**ISSUE:** Certificate of Appropriateness for alterations

**APPLICANT:** HF Entwisle LLC

**LOCATION:** 437 N. Columbus Street

The applicant requests a Certificate of Appropriateness for alterations and repairs to the rear second and third floor porches at 437 N. Columbus Street.

Figure 1: Existing

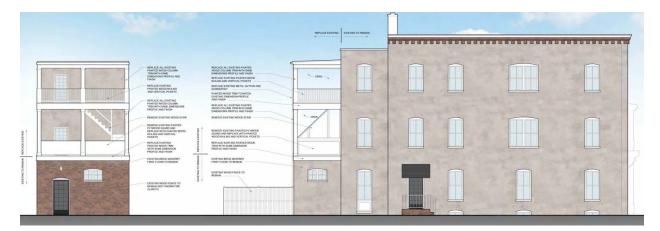
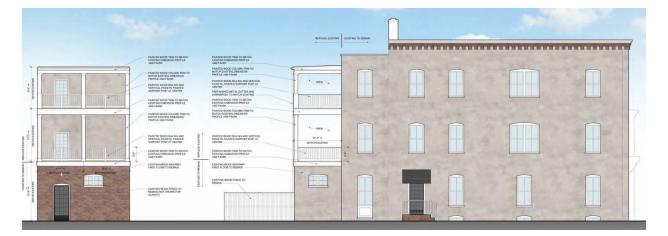
- Removal of the existing stair connecting the second and third floors
- Replacement of the wood columns, railings and trim
- Installation of a wood picket railing at the second-floor to match the third floor railing
- Replacement of the existing sloped roof with a new roof with the same slope.
- Painting all wood white

Staff finds that the proposed porch alterations comply with the following guidelines in the Porch chapter of the *Design Guidelines*: "Porches should be appropriate to the historical style of the structure" and "Porches should generally be painted the predominant color of the building or the color of the trim work." While staff believes that the porches do not date to the original period of construction, they may have been constructed as early as the early 20<sup>th</sup> century when the first-floor addition was constructed. There have been numerous repairs to the porches over the years, but the current condition requires more extensive repair and replacement to make them structurally sound. Staff is pleased that the applicant intends to use wood as the predominant replacement material and supports the replacement of the solid wood railing at the second story with historically appropriate wood pickets.

Staff recommends approval of the project, as submitted.
